**DEPARTMENT OF
CITY PLANNING**

June 8, 2017

Re: City Planning Case Nos: VTT-73427-2A and
ENV-2014-3995-EIR
Related Case: CPC-2004-7308-ZC-ZAD-K and appeal
Project Address: 9503 N. Andora Place, Chatsworth

APPEAL ANALYSIS

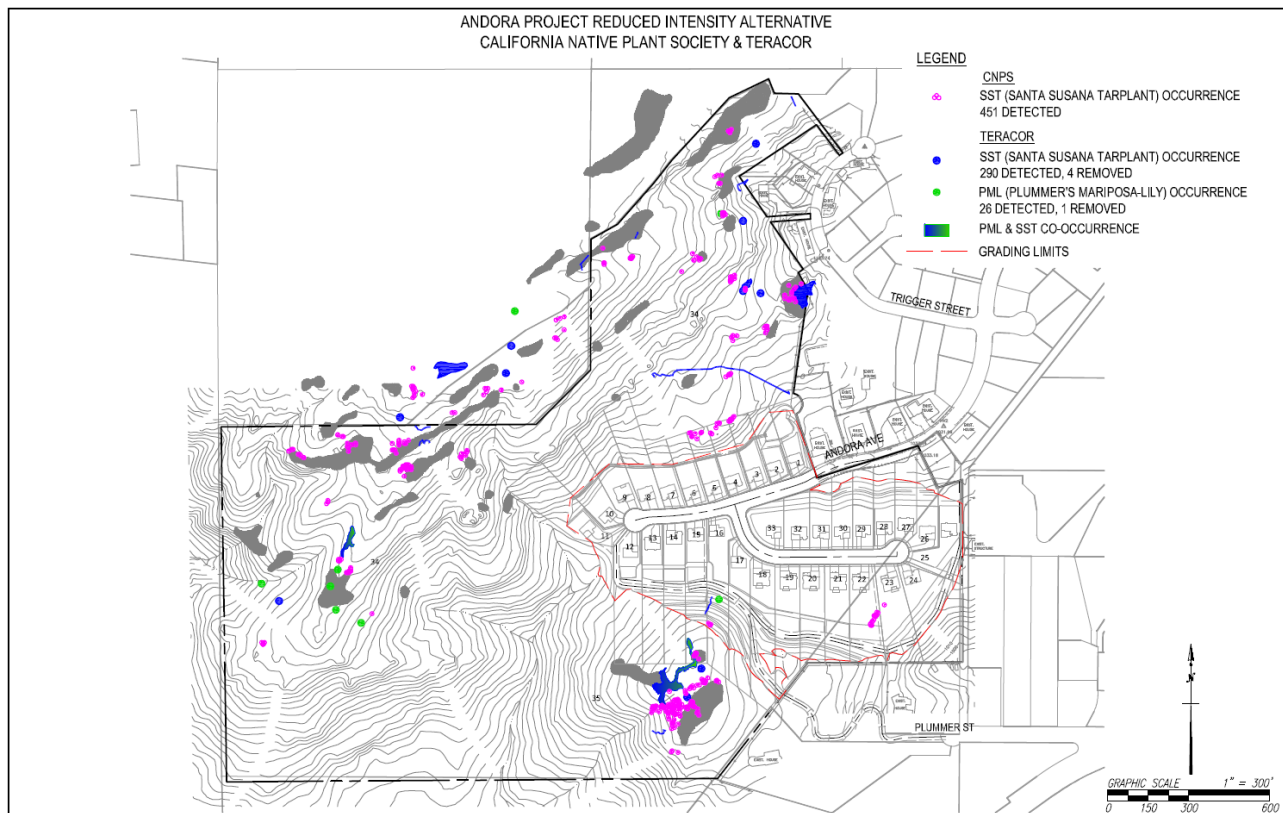
The CNPS stated that the methods and timing of the biological surveys resulted in an underreporting of plants and wildlife; that the surveys lacked information on arthropods (insects), bryophytes (mosses, lichens, liverworts), and fungi; and additional focused rare plant surveys should have been conducted (including in cooler season in early spring and mid-summer).

- **Four additional flora and fauna surveys:** Additional surveys were conducted by Biologists Jared Reed and Michael C. Long on April 27th and June 1st through June 3rd, 2016 (Final EIR Appendix B.1 and B.2), and included a survey of the special status species - Santa Susana tarplant and Plummer's mariposa lily (Final EIR, Figure III-9: Sensitive Plant Impact Map, page III-55).

Surveys were conducted during the Spring, Summer, and Fall seasons and presented an accurate depiction of the flora and fauna on-site. Focused surveys were conducted for special status species such as the Santa Susana tarplant and mariposa lily, and no other special status species were documented during the numerous on-site surveys conducted over the past decade.

Figure III-8 of the Final EIR (page 54), identifies the sage scrub habitat in orange, with the red outline indicating the grading limit and white areas identifying fuel modification areas:

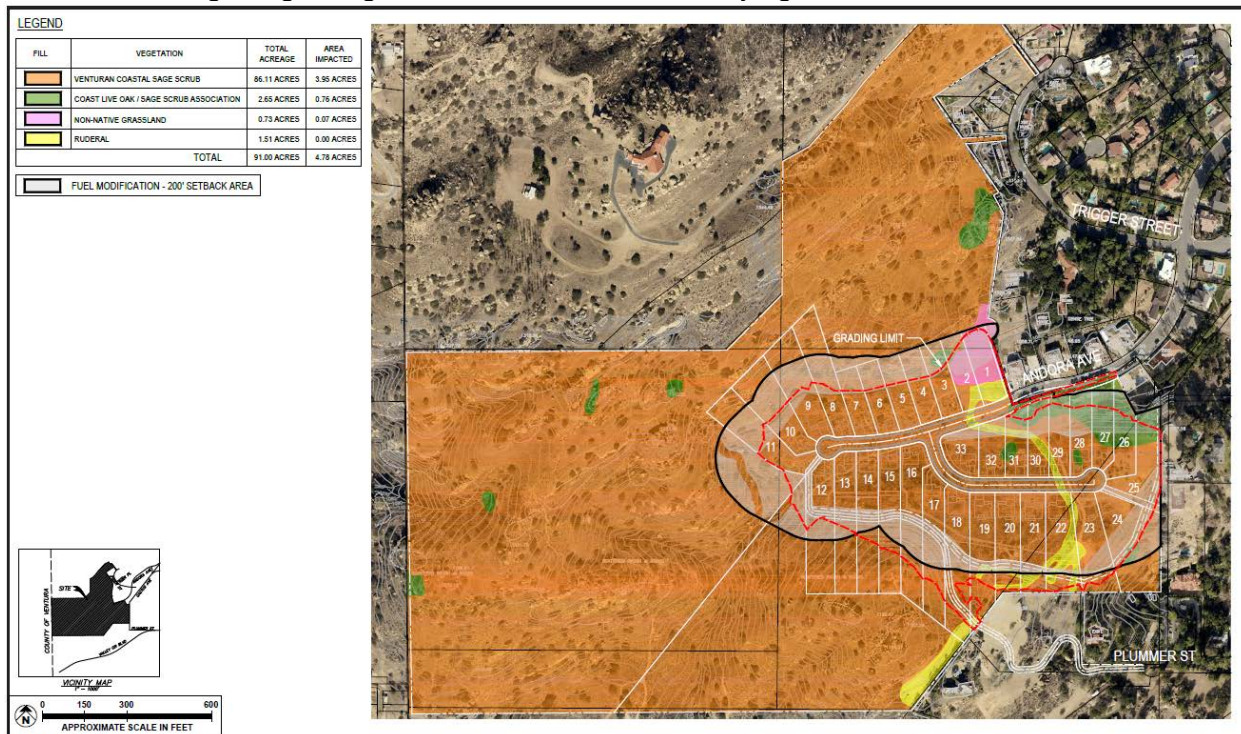
The CNPS states that over 30 acres of sage scrub habitat will be impacted, including impacts from brush clearance, and that the EIR fails to analyze avoidance and protection of habitat, and the EIR fails to analyze long-term and cumulative impacts due to edge effects.

As noted in Response 2-11 (page 56) of the Final EIR:

“Although Venturan coastal sage scrub is not subject to the same standards of protection as endangered plants or animals, the Project Applicant has actively sought to reduce losses of Venturan coastal sage scrub by reducing the size of the 35-lot VTTM Project footprint and dedicating approximately 77 acres to the Mountains Recreation and Conservation Authority (MRCA) for conservation. As a result, the proposed 35-lot VTTM Project will directly impact approximately 18.11 acres of Venturan coastal sage scrub through grading. In addition, 3.95 acres of Venturan coastal sage scrub will be subject to periodic fuel modification. These temporal impacts to Venturan coastal sage scrub comprise 25 percent of the total Venturan coastal sage scrub on-site.

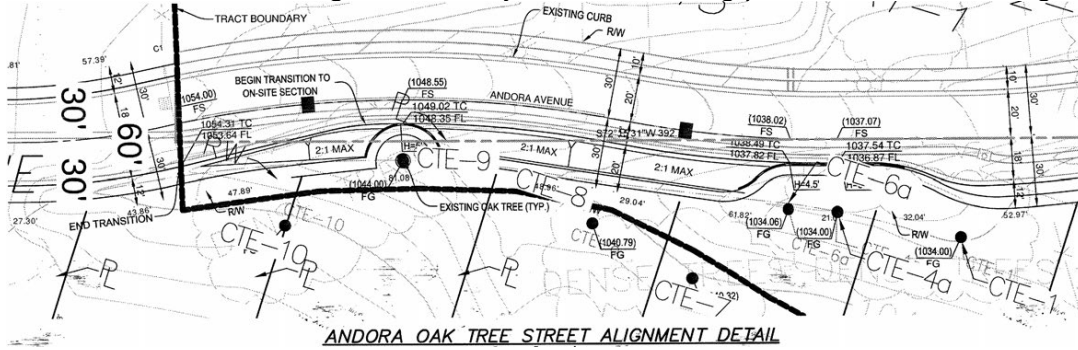
As described in the Final EIR (pages III-58 and III-112), impacts to most of the trees on the Project Site will be avoided. A total of 29 oak trees greater than 4-inch caliper diamond trunk were identified in the “Tree Report” prepared by Richard W. Campbell, ASLA, January 12, 2015 (Draft EIR, Appendix D). Of those trees, up to eleven oak trees will be impacted by the project, including five trees which are located within the project grading footprint and will be removed, and six trees which are located along the south side of Andora Avenue and will be conserved but affected via minor incursion into the protected zone of the oak tree associated with the extension of Andora Avenue.

The map excerpt below (Draft EIR Appendix D, Tree Map) identifies in yellow the five trees in three locations which are proposed for removal. These trees are all located in areas to be graded or filled within the central portion of the development area, where preservation in-place would preclude a reasonable development of the site. Therefore, justification for their removal is warranted. A total of 18 trees of the 29 will be avoided and conserved. The coast live oak/coastal sage scrub that has been avoided will also be placed into a conservation easement in favor of the MRCA.

Oak tree mitigation was adequately addressed through regulatory compliance and mitigation measures identified in the EIR. As part of regulatory compliance, the project would conform to the City's Protected Tree Ordinance. All protected tree removals require the approval of the Board of Public Works and the issuance of a protected tree removal permit by the Urban Forestry Division, which requires maintenance and bonding for survival of trees for a minimum of three years and making the necessary findings under the City Native Tree Ordinance. If the findings aren't made, then the permit will not be granted and the trees cannot be removed. If the tree removal permits are granted, Mitigation Measure C-5 requires the following replacement ratios for any impacted trees: trees within CDFW jurisdiction are subject to replacement ratios ranging from 2:1 to 15:1 depending on tree size, and trees outside of CDFW jurisdiction are subject to a replacement ratio of 4:1, which is greater than the 2:1 replacement ratio required by the Los Angeles Municipal Code. In addition, the Andora Avenue roadway will be modified to preserve as many existing oaks in place.

In response to the appellant's concerns, and at the recommendation of the CDFW to ensure the success and survival of replacement oak species, the applicant has voluntarily agreed to extend the oak tree monitoring period from three to seven years and therefore the following language should be added to MM C-5:

MM C-5: ...(add): The applicant shall post a bond or other assurance acceptable to the City Engineer to guarantee the survival of trees required to be replaced or permitted or required to be relocated, in a manner to assure the existence of continuously living trees at the approved replacement or relocation site for seven years from the date that the trees are replaced or relocated.

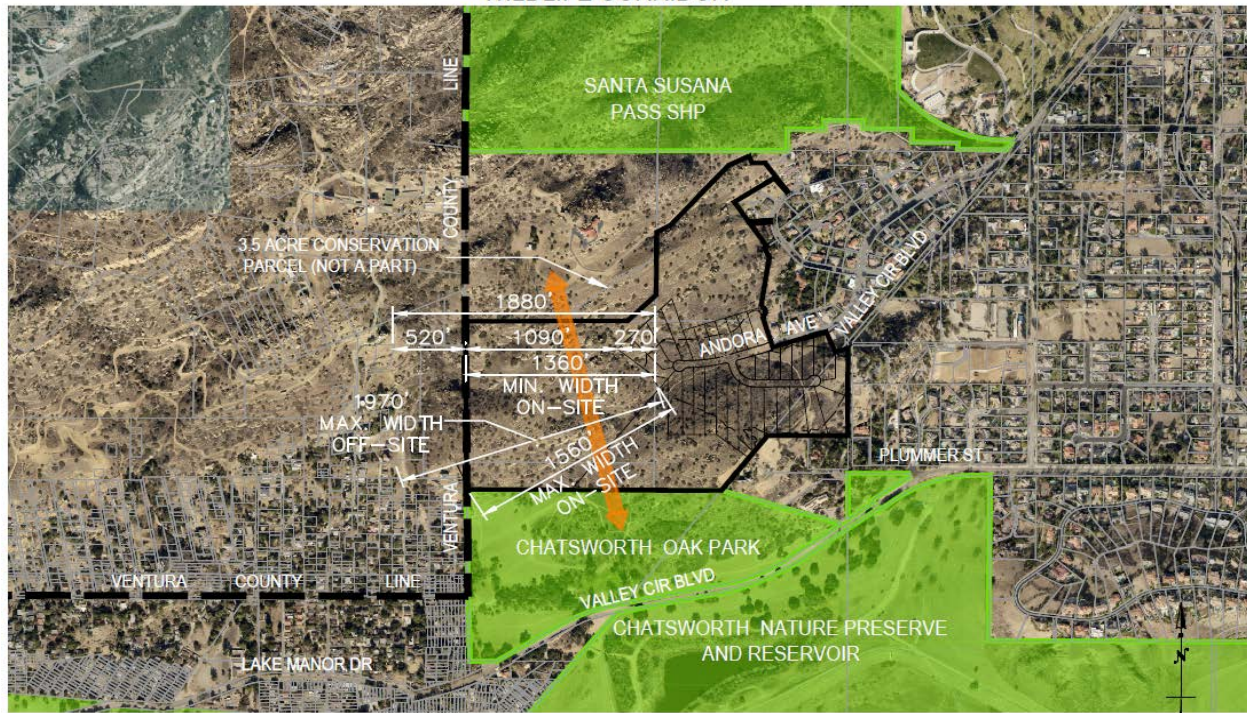
The existing wildlife corridor within the project site is of regional importance, the project's proposed wildlife corridor widths are inadequate due to edge effects and topographic constraints, and cumulative impacts were not properly addressed.

The project site is currently undeveloped, and is located directly south of the 680-acre Santa Susana State Historic Park and an approximately 46-acre property developed with a single-family residence. The site is also located directly north of Chatsworth Oaks Park, which is adjacent to the Chatsworth Nature Preserve and Reservoir. Chatsworth Oaks Park is an approximately 50-acre City-owned park located along the north side of Valley Circle Boulevard. A majority of the park is undisturbed open space and trails, with a chain-link fence separating the entire site from the roadway, and with a limited portion of the park developed with surface parking, a children's playground, barbecue pits, picnic tables, and an open grassy area. The 1,325-acre Chatsworth Nature Preserve is located along the south side of Valley Circle Boulevard and functions as a natural open space preserve. Limited portions of the property also contain paved roadways and infrastructure previously utilized by the Department of Water and Power for the Chatsworth Reservoir. The site is inaccessible to the public, and terrestrial wildlife access to the Nature Preserve is somewhat encumbered by a chain-link fence that surrounds the entire property. From the Andora Subdivision project site, wildlife has unencumbered access from the site to the Santa Susana State Historic Park and privately-owned areas to the north, to the Simi Hills and privately-owned areas to the west, and Chatsworth Oaks Park to the south. However, intervening hillside topography and some sparse development does inhibit access throughout the area.

As noted in the Final EIR, *Response to Comments, Topical Reponse No. 1 – Wildlife Movement*: “According to the Natural Resources Conservation Service, corridors are linear strips of vegetation that differ from the adjacent surroundings and which function to conserve soil, water, plants, wildlife or fish resources. Studies indicate that the recommended width for wildlife movement corridors generally ranges from 300 meters (approximately 1,000 feet) for sub-regional corridors to 500 meters (approximately 1,600 feet) for regional corridors. Regional corridors are primary landscape connections between larger areas of habitat. Sub-regional corridors, while not as large in width as regional corridors, should be wide enough to provide landscape connections for species movement and dispersal. The proposed 1,560-foot-wide corridor would generally meet those standards.”

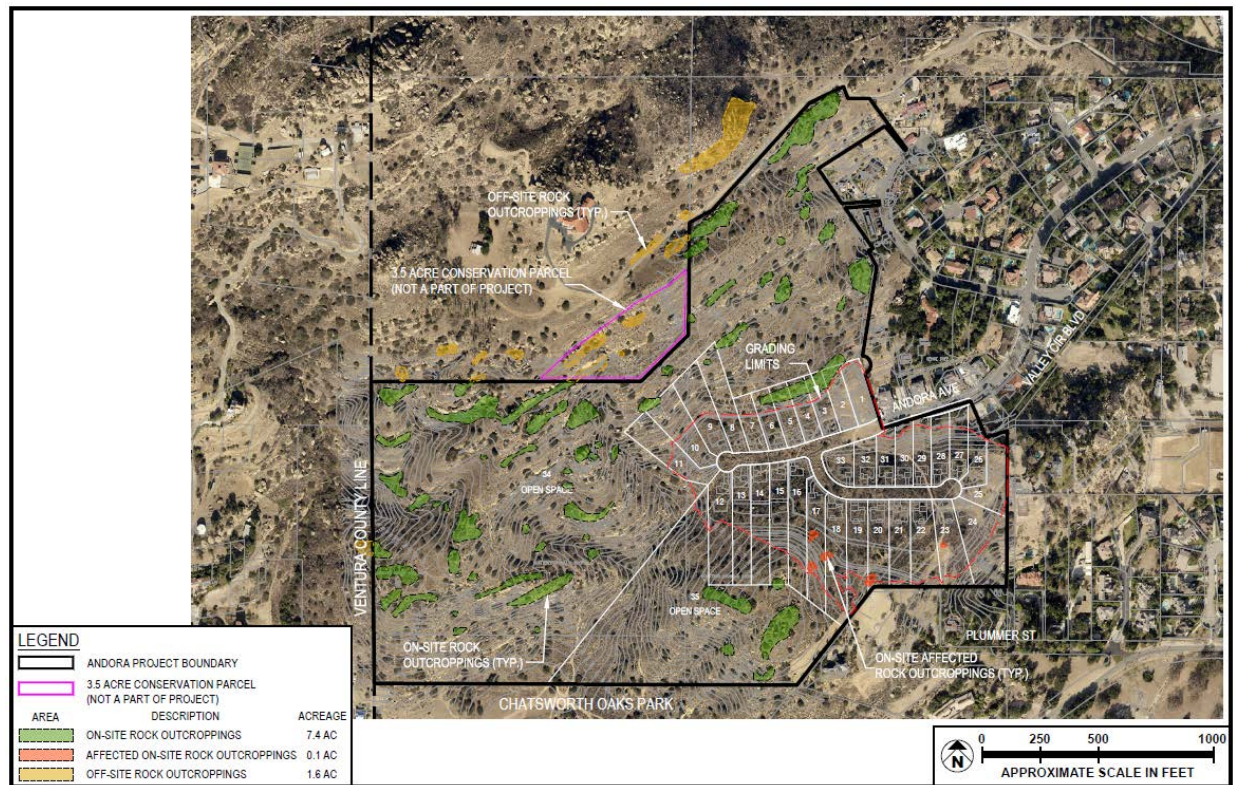
The number of impacted Santa Susana tarplants and rock outcroppings is inaccurate.

Please see Response to CNPS Appeal Point 1 (pages 3-5): *Santa Susana Tarplant.*

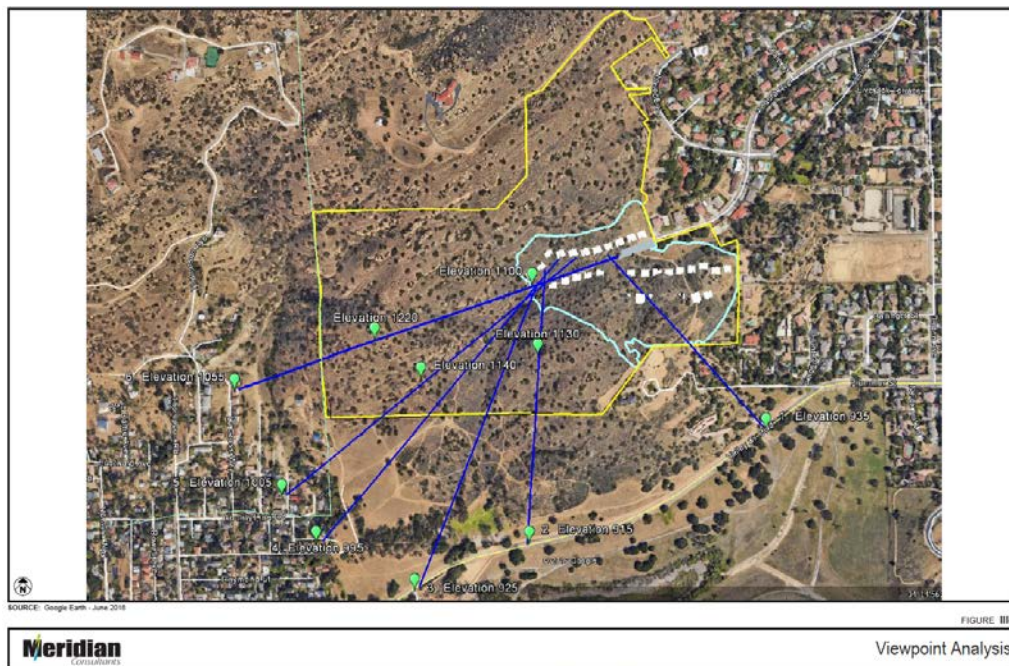
The development will diminish views from Valley Circle Boulevard and Chatsworth Oaks Park.

As discussed in Section IV.A, Aesthetics, in the Draft EIR, and in Topical Response No. 2 - Visual Character of Area, in the Final EIR, aesthetic and viewshed impacts would be less than significant. The project would be developed with low-density residential housing that is consistent with existing residential properties in the immediate vicinity. The intervening topography between the portion of the Project Site that would be graded and developed with the proposed 33 homes would obstruct views of the proposed homes from Valley Circle Boulevard and the community of Chatsworth Lake Manor, as evidenced in Final EIR, Figure III-2, Viewpoint Analysis, and Figure III-3, Representative Views below.
